Re: Harbourside Shopping Centre Redevelopment - Podium and Tower (SSD-49295711) (Podium and Tower DA)_ Submission on Behalf of the Owners of Strata Plan 49259 (One Darling Harbour)

Re: Harbourside Shopping Centre Redevelopment Modification 3 Amend the Tower Height and Podium - SSD-7874-Mod-3 (MOD 3) - Submission on Behalf of the Owners of Strata Plan 49259 (One Darling Harbour)

**SSD 7874 Redevelopment of the Harbourside Shopping Centre
Addendum to Presentation made to the Independent Planning
Commission**

Figure 1
Principle for more appropriate view sharing
(Adapted from part of Page 3, FJMT Supplementary Architectural Design Report)

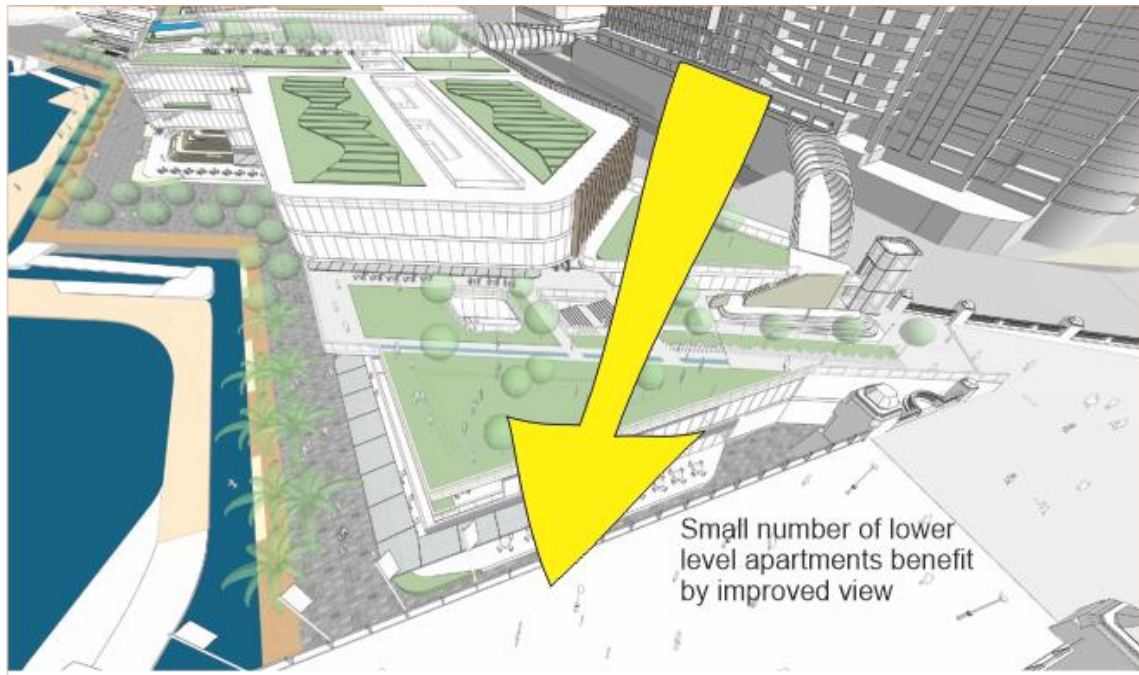
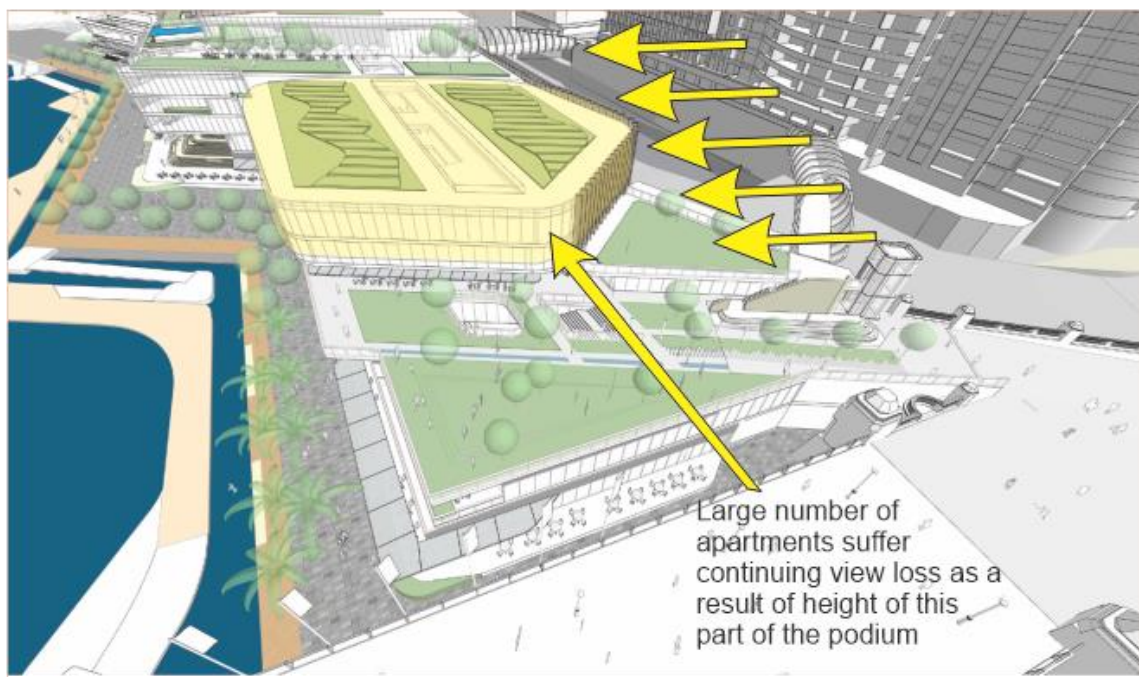
The shape of the area in plan that is proposed to be included in the potential Guardian Square plaza is of limited benefit in view sharing to One Darling Harbour. This is illustrated in the figure above and in the photomontages prepared by Virtual Ideas. However, the lower podium is an improvement to the views from a small number of units, that is appreciated.

Reconsideration of the height, the function and the likely future character and height of items that could be approved on this part of the podium could provide a satisfactory outcome for One Darling Harbour in terms of view sharing.

Figure 1
Principle for more appropriate view sharing
(Adapted from part of Page 3, FJMT Supplementary Architectural Design Report)

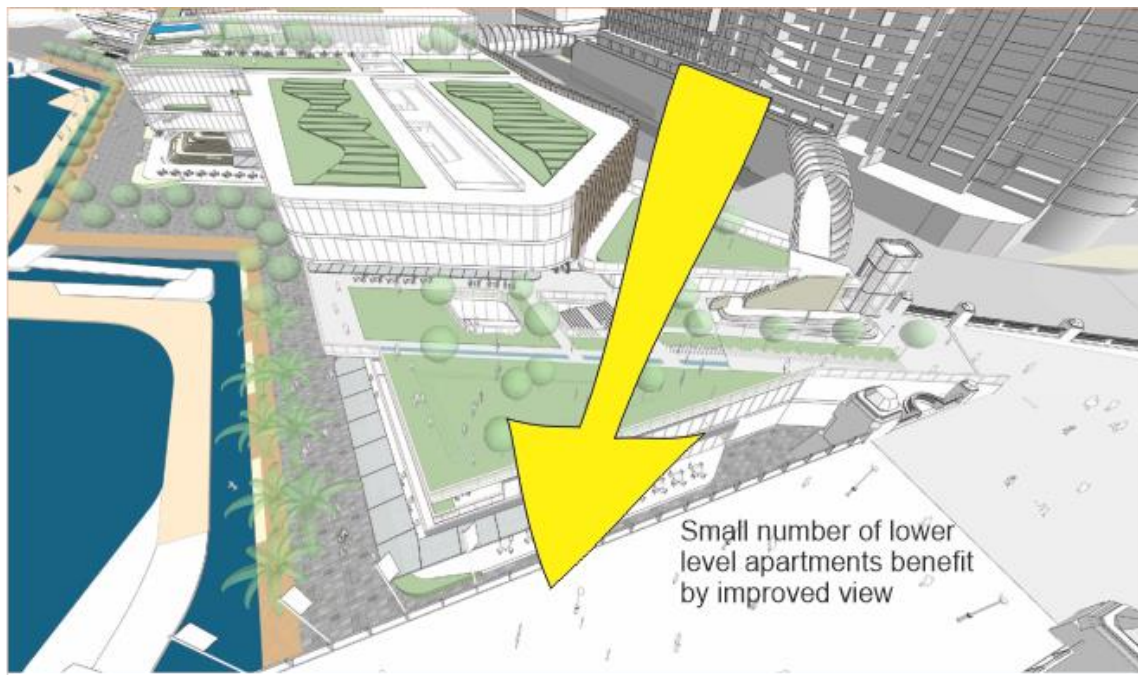
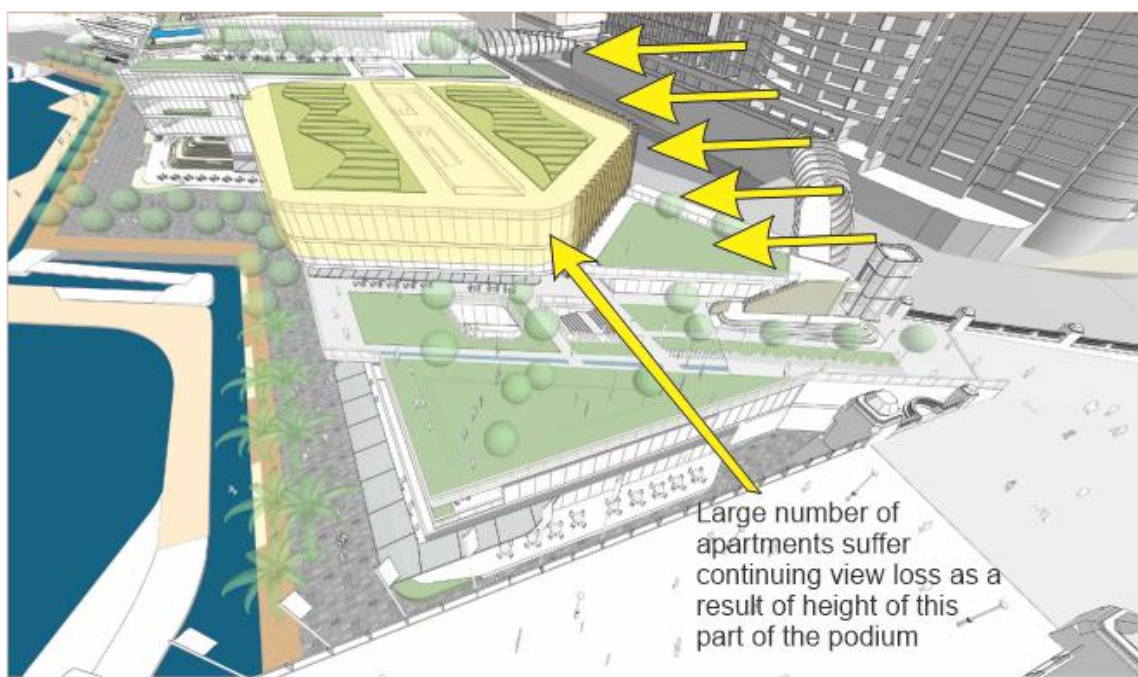
The shape of the area in plan that is proposed to be included in the potential future plaza is such that it is of limited benefit in view sharing however, as it is at its narrowest toward One Darling Harbour and the part that extends more widely to form the plaza and link to Harris Street is largely out of view, blocked for most apartments by the higher part of the north-east section of the podium. The main reasons for the shape of the 'cut out' on the podium appear not to be primarily to achieve view sharing, although there is a minor benefit there, but are the alignment with a formal link to Harris Street, space for a link across Darling Drive to One Darling Harbour and a link to the foreshore.

The lower podium is an improvement to views from One Darling Harbour that is appreciated, but the benefit should be extended by moving the south boundary of the lowered section of the podium further south and on an alignment more directly easterly, for example to the alignment of the next step in height in the podium that is proposed further to the south.

I have noted the part of the podium that is still of concern with regard to view sharing with One Darling Harbour on Figure 1 below, by means of a transparent yellow fill on a graphic adapted from Image 31 from the FJMT Supplementary Architectural Design Report. The slot in the podium benefits a small number of apartments, whereas the height of the part of the podium shaded yellow causes continuing unreasonable view loss for a much larger number. Reconsideration of the height of this part of the podium could provide a satisfactory outcome for One Darling Harbour in terms of view sharing.

Private view impacts of northern podium (paragraph 9)

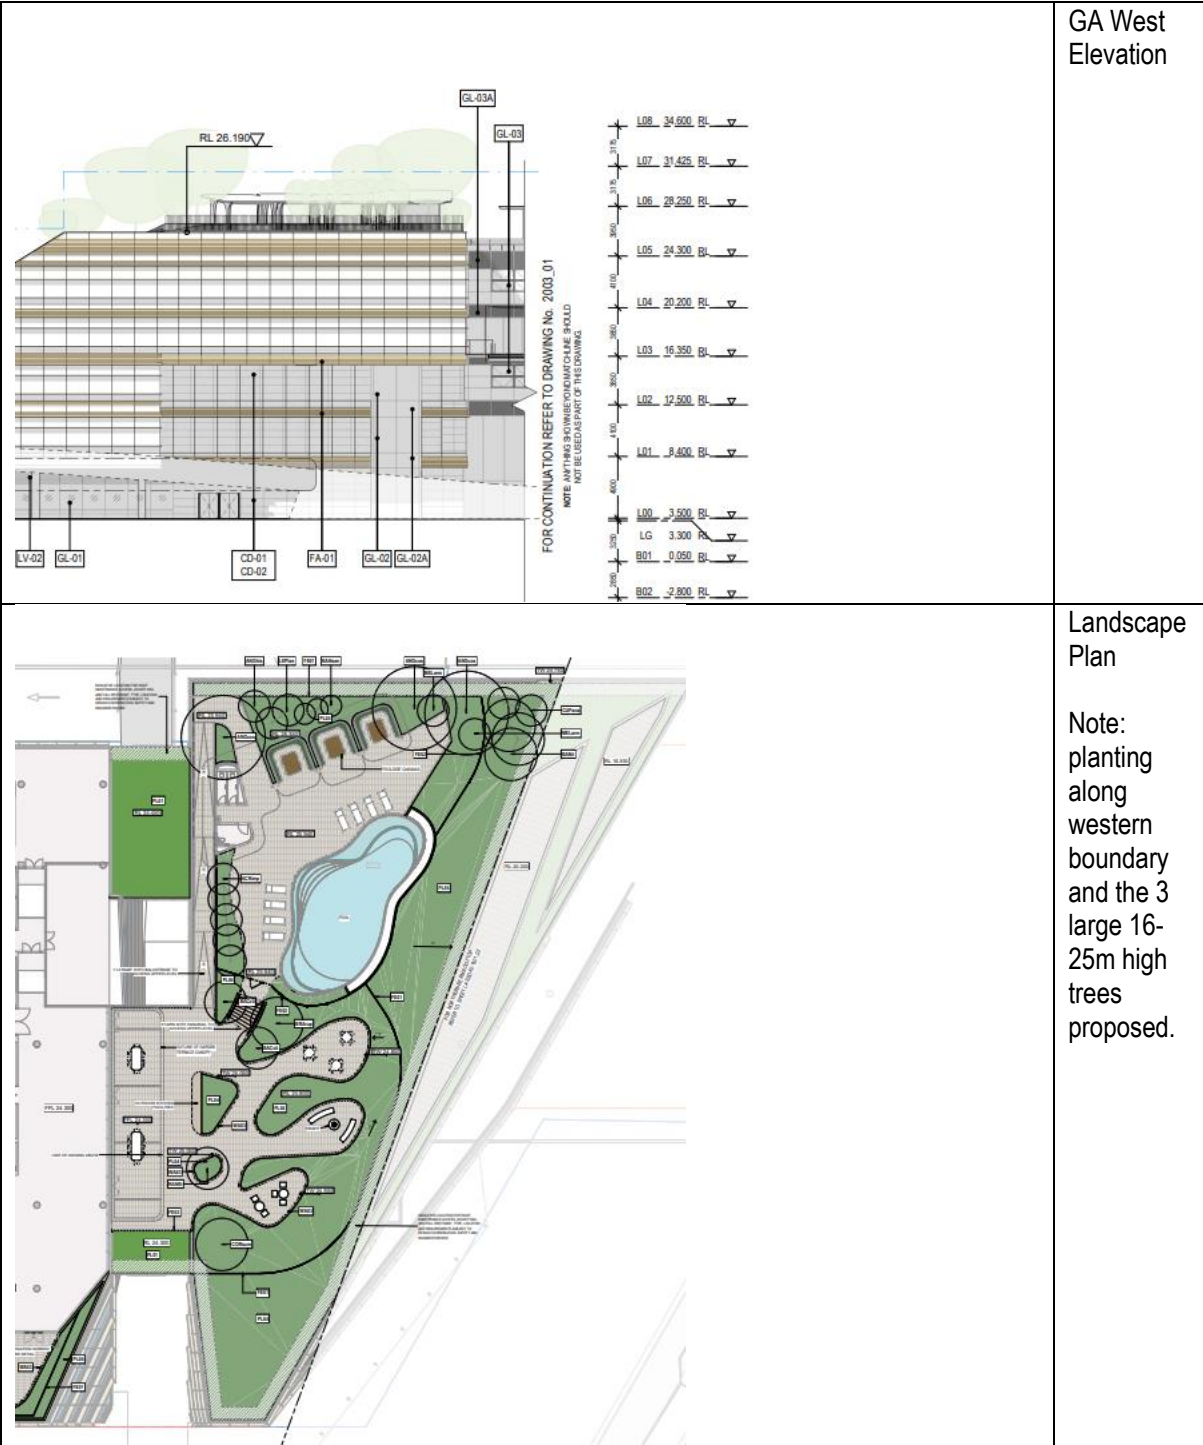
11. In relation to the impacts of hard landscaping, there is no basis for the development to exceed 12.5m RL. If the proponent has elected to reconfigure its floor plan to reduce the available space on the roof of the northern podium from circa 4,600sqm to only 3,500sqm, then it is incumbent on it to fit within that floor plan spaces for deeper soil planting to allow soft landscaping of Waterfront Park. See image at Attachment E.

Available space on the northern podium (paragraph 11)

Public Domain Impacts – paragraph 24

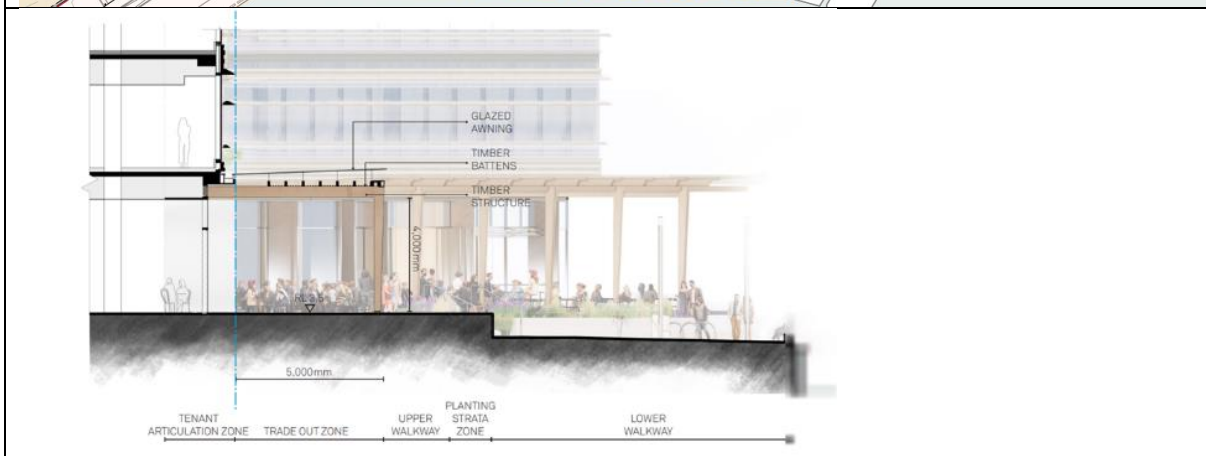
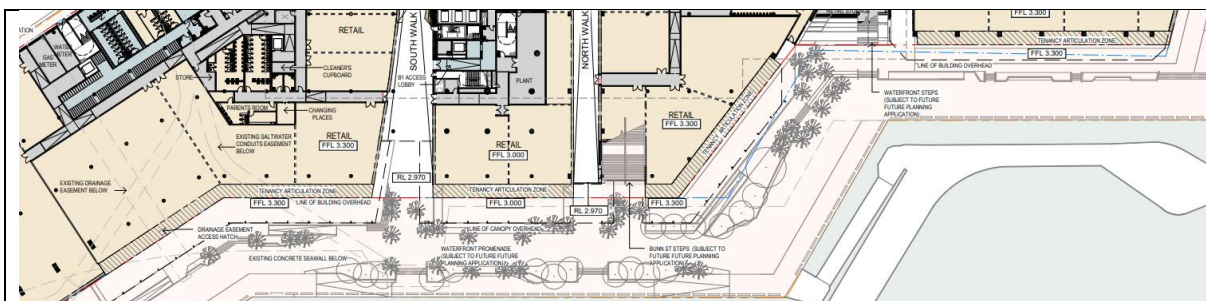
<p>Drawing of Bunn St stairwell and Event stairs in Tower and podium DA.</p> <p>Note reduction functionality of Event Stairs for events and gatherings</p>
	<p>Image of possible configuration of public domain in Tower and Podium DA</p>
<p>Figure 29 Indicative waterfront boulevard treatment (Source: Applicant's EFRIS)</p>	<p>Proposal as submitted for concept approval. Note wide waterfront promenade (including potential for markets)</p>

Figure 26 'Kit of parts' facade options and resultant facade articulation - Waterfront Promenade
Source: Snøhetta and Hassell

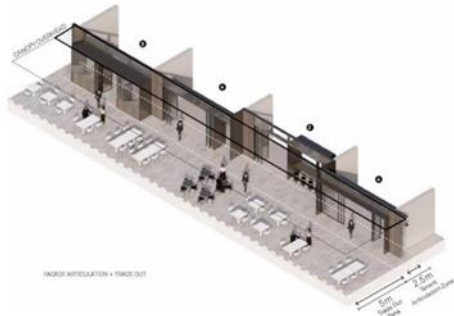
(Note narrowing of space available for the public and pedestrian movement and creation of “private retail spaces” in the public domain by steps/height change and planting).
